Subject: **Bid No. 8819-M7 – Sprinkler & Fire Alarm Modifications – Union Station / WRA**

ADDENDUM NO. 3

SPRINKLER AND FIRE ALARM
MODIFICATIONS PHASE 2
UNION STATION
WORCESTER, MA

E100

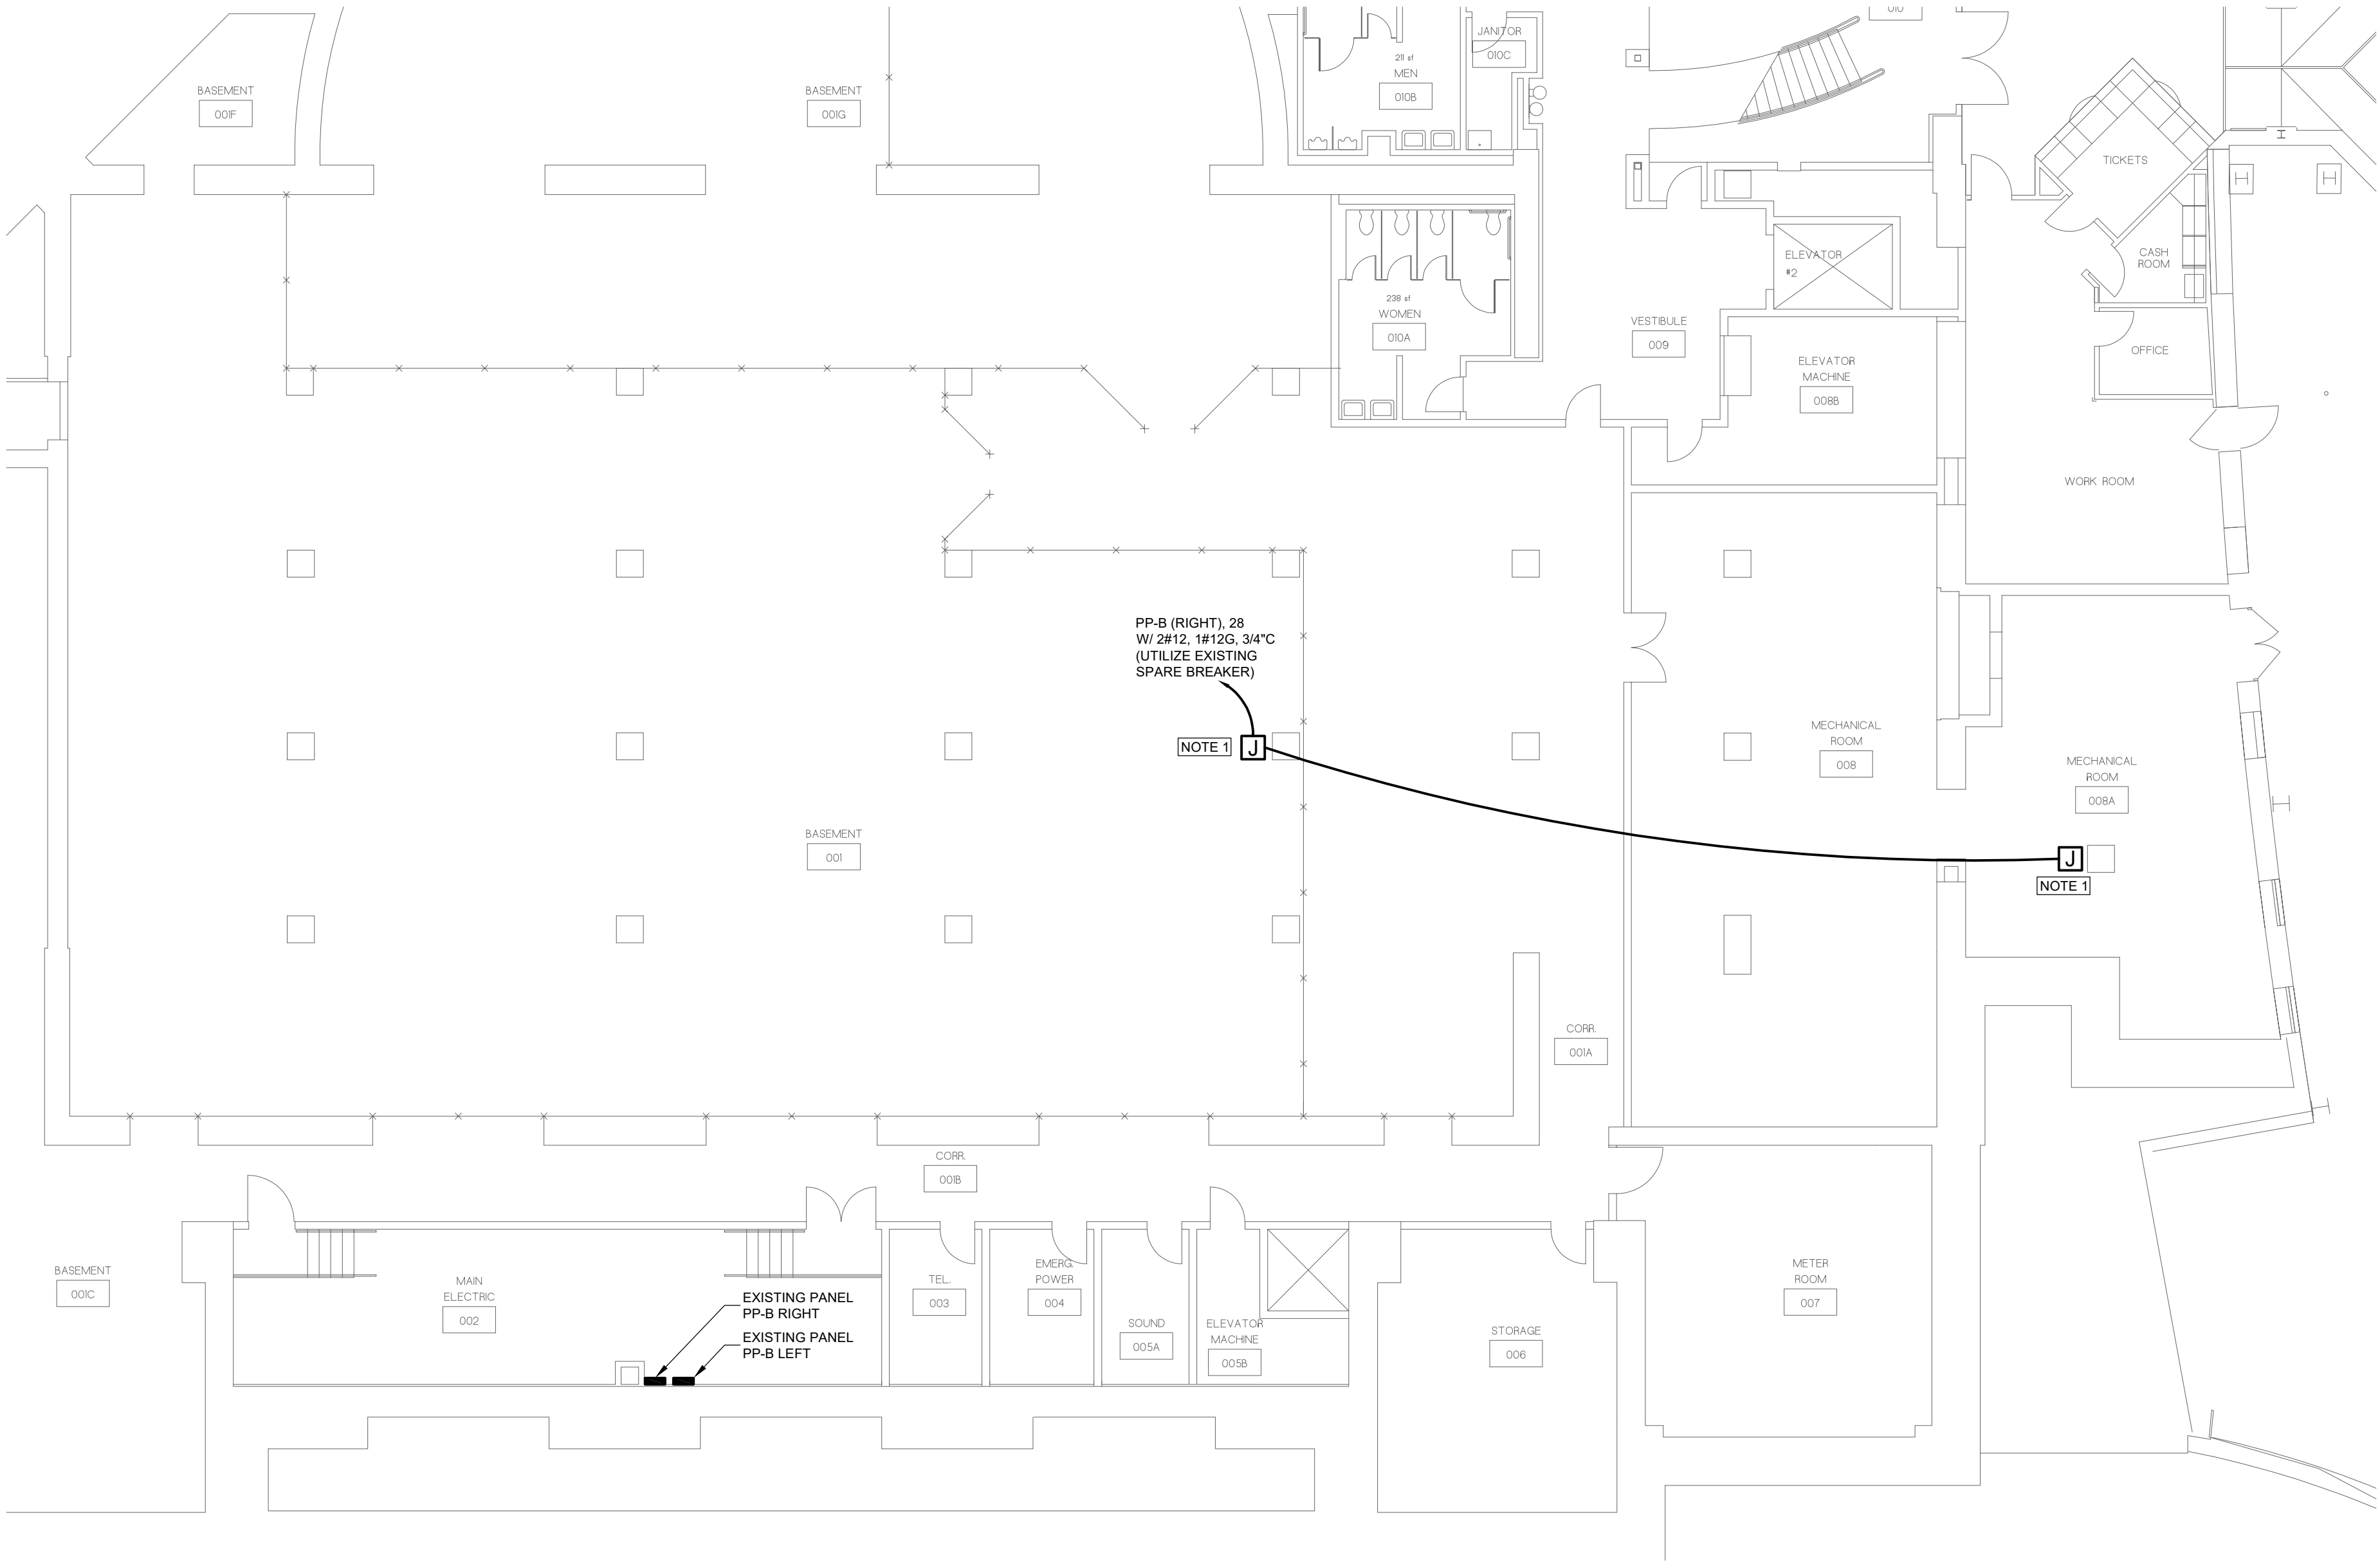
- ADD sensor schedule.
- ADD Leak Detection Detail.
- ADD Drawing E100, Electrical Power Partial Basement New Work Plan, adding junction boxes to provide power for leak detection controllers.

E101

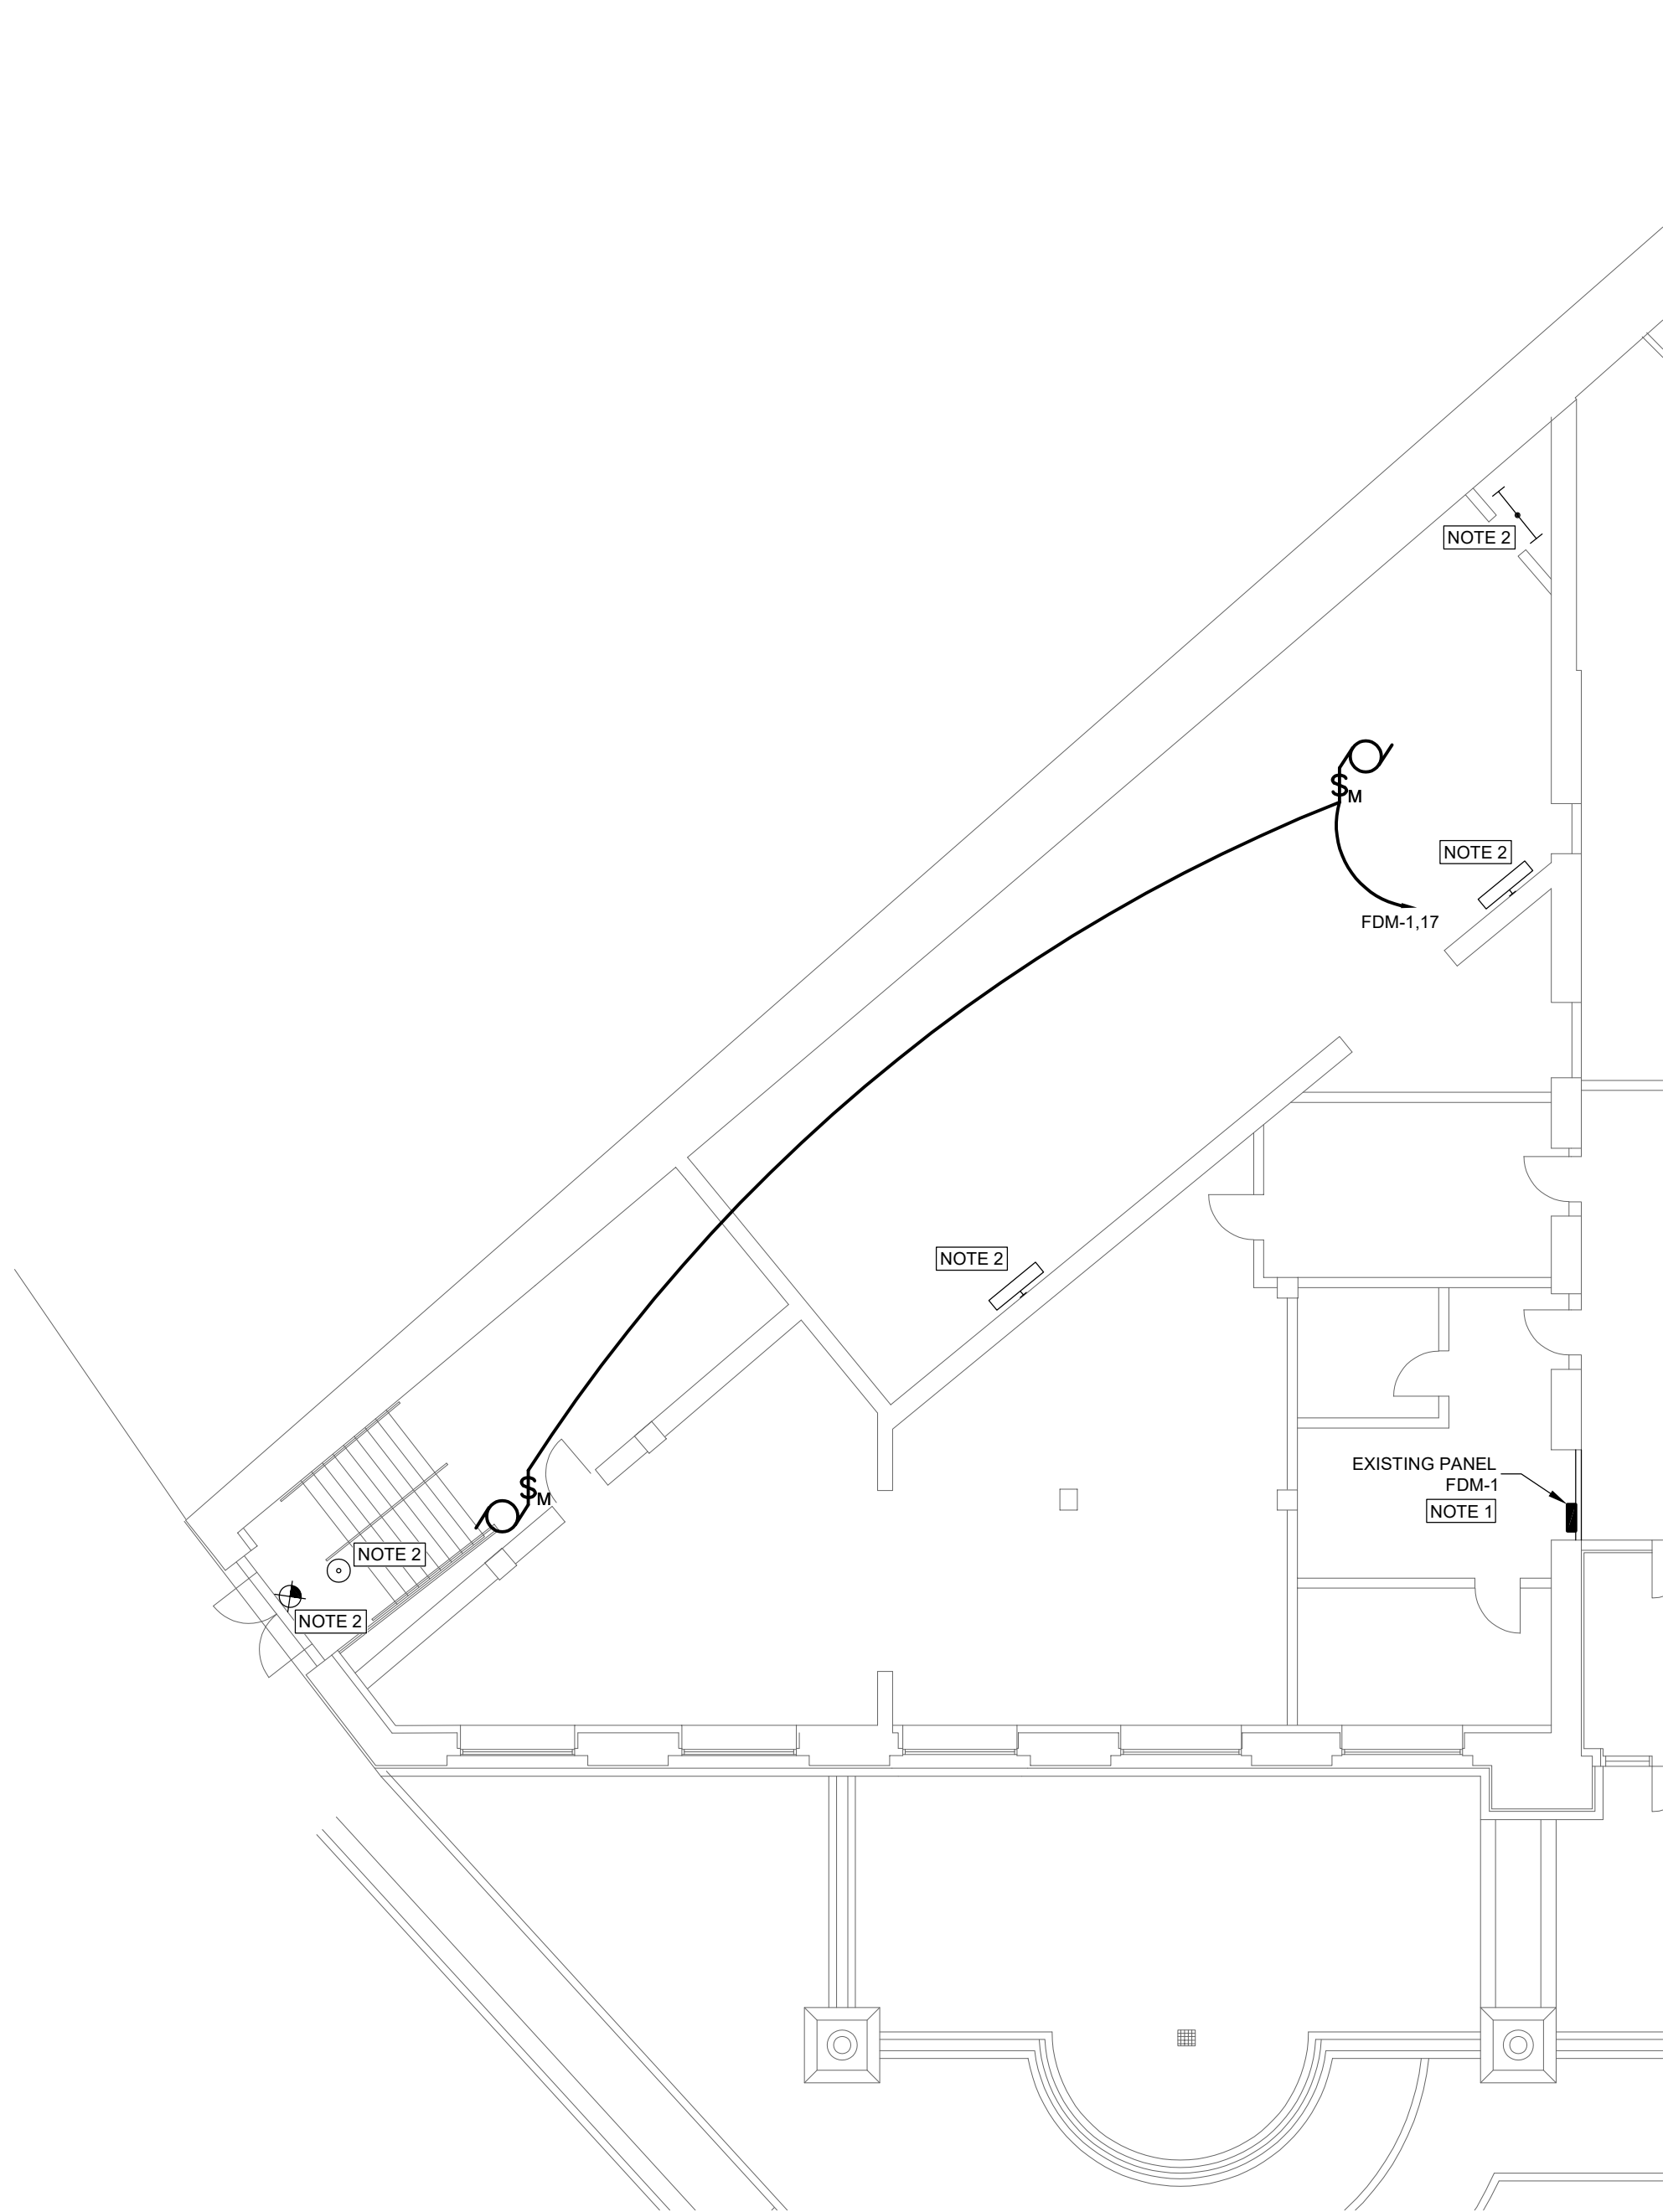
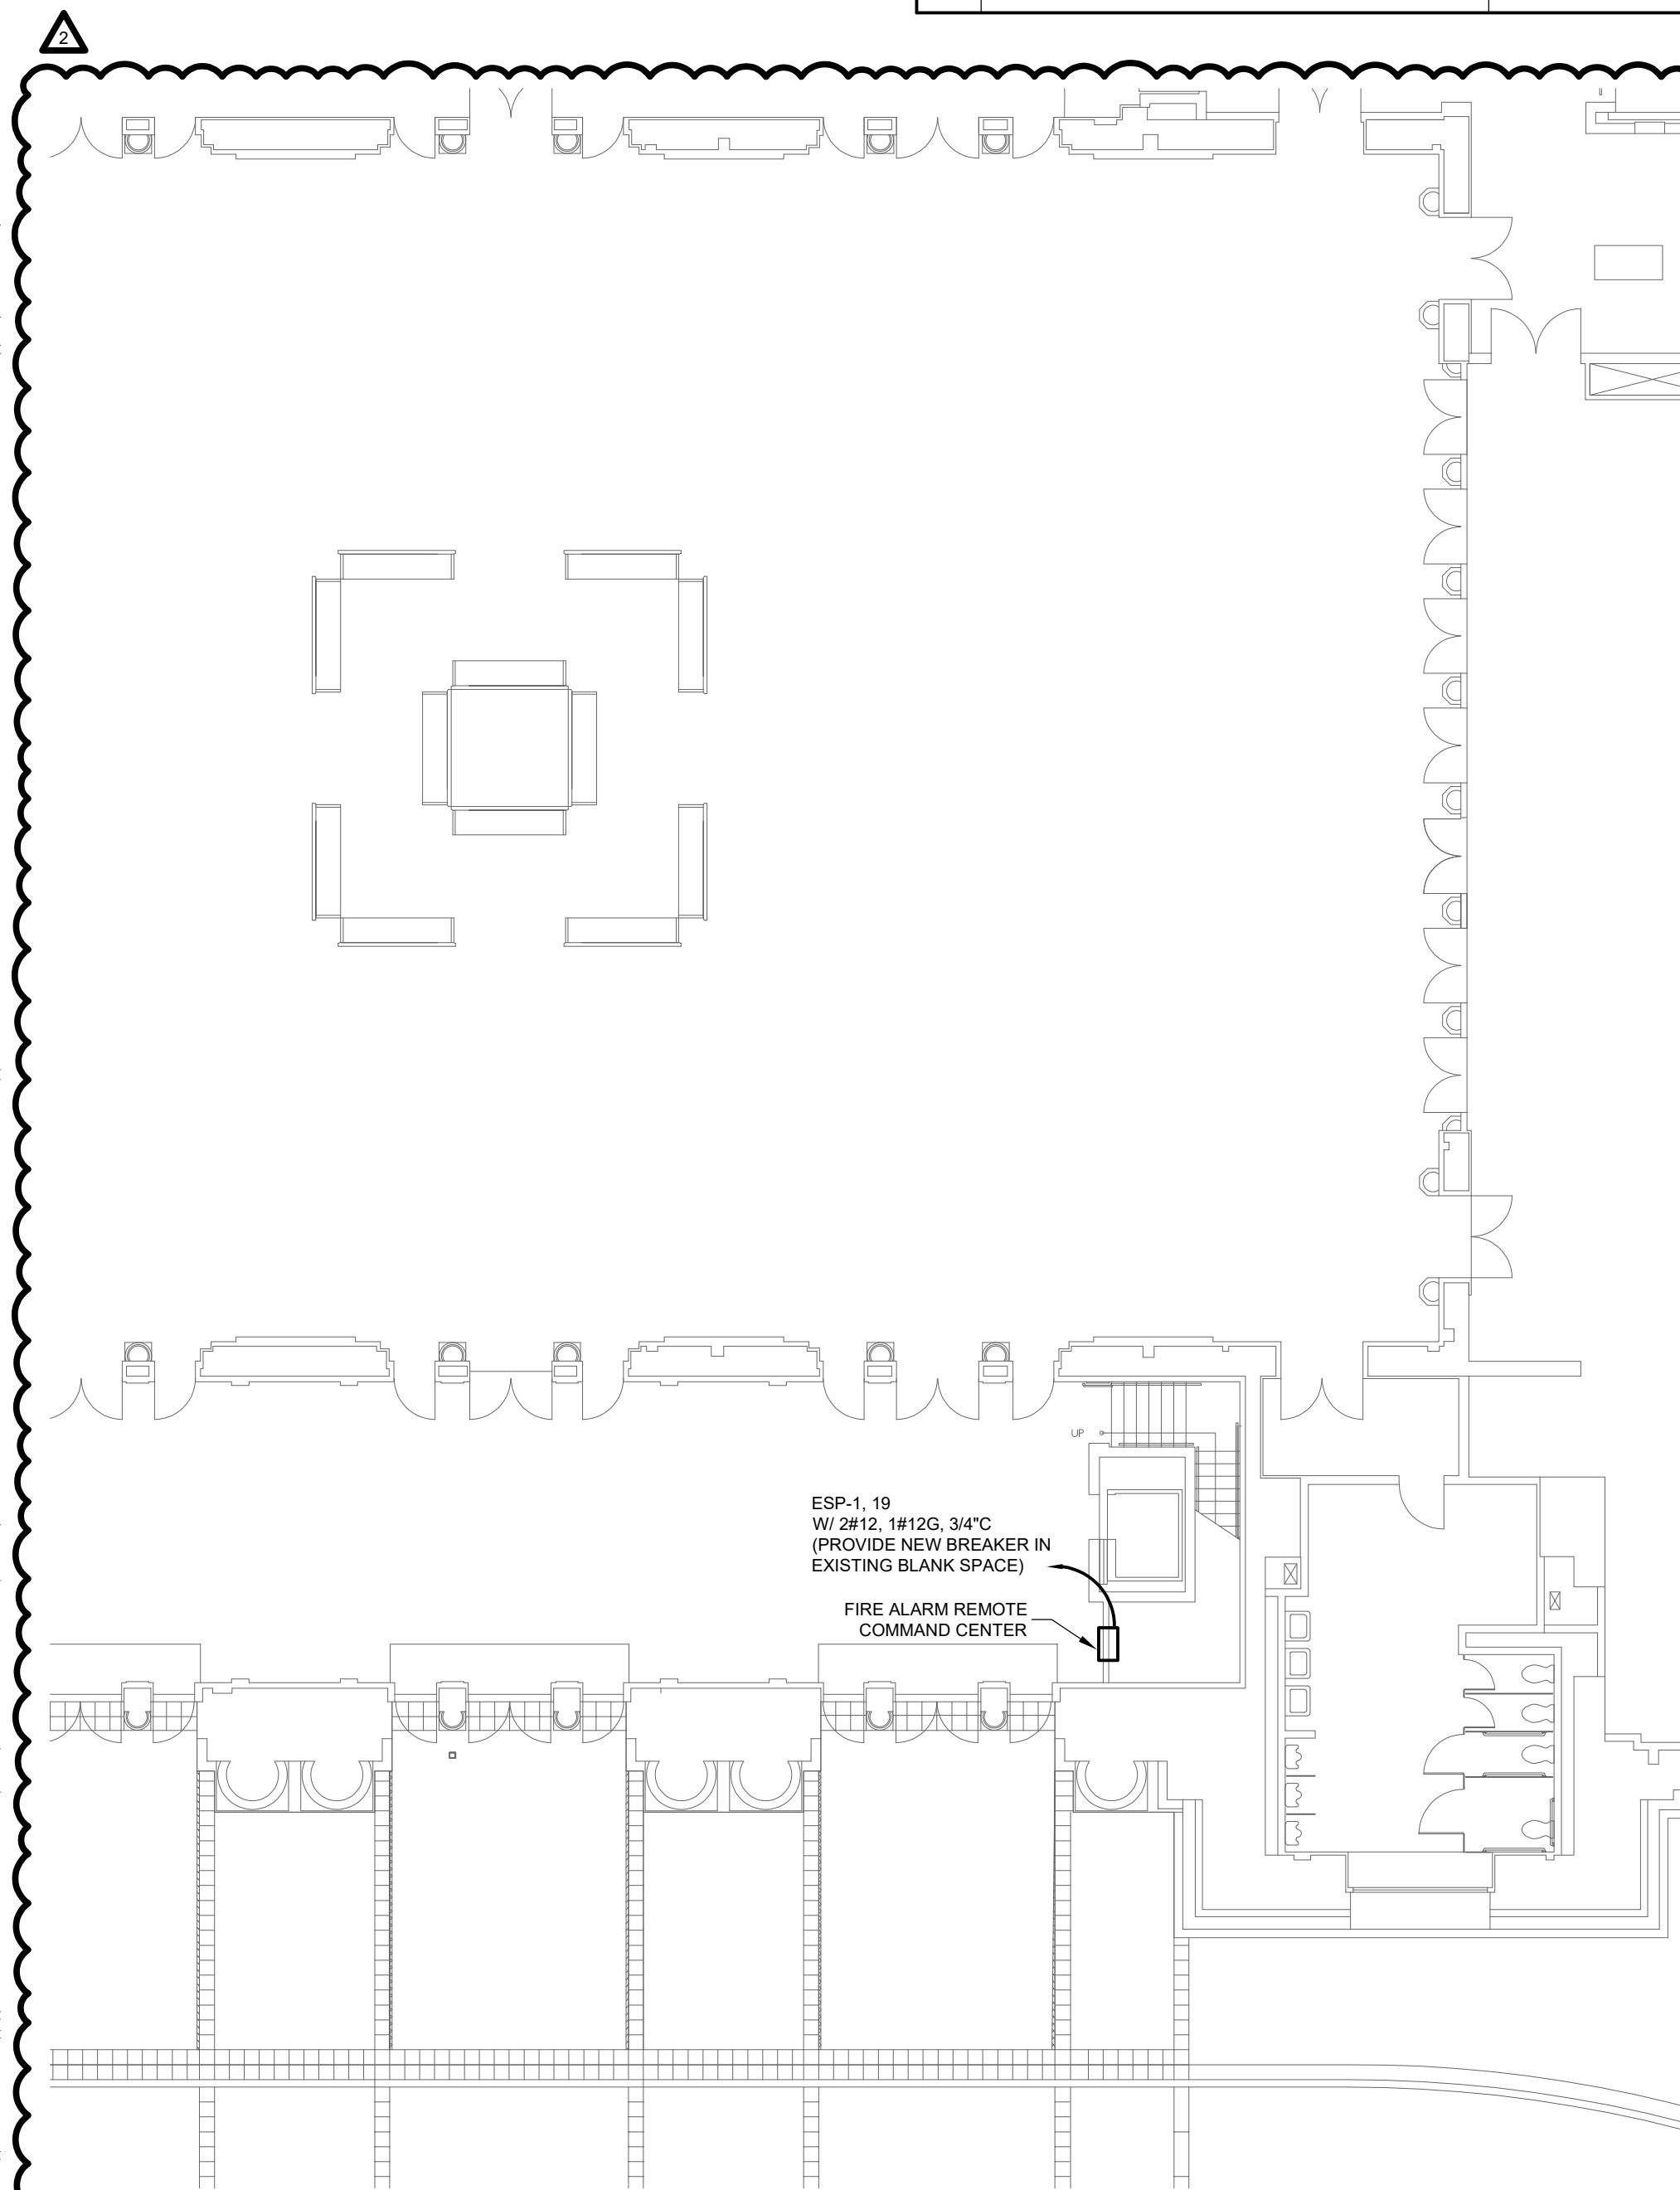
Drawing E101, Electrical Power Partial First Floor New Work Plan, Revise as follows:

- ADD power supply circuit for fire alarm remote command center.
- ADD panel schedule for existing Panel ESP-1.
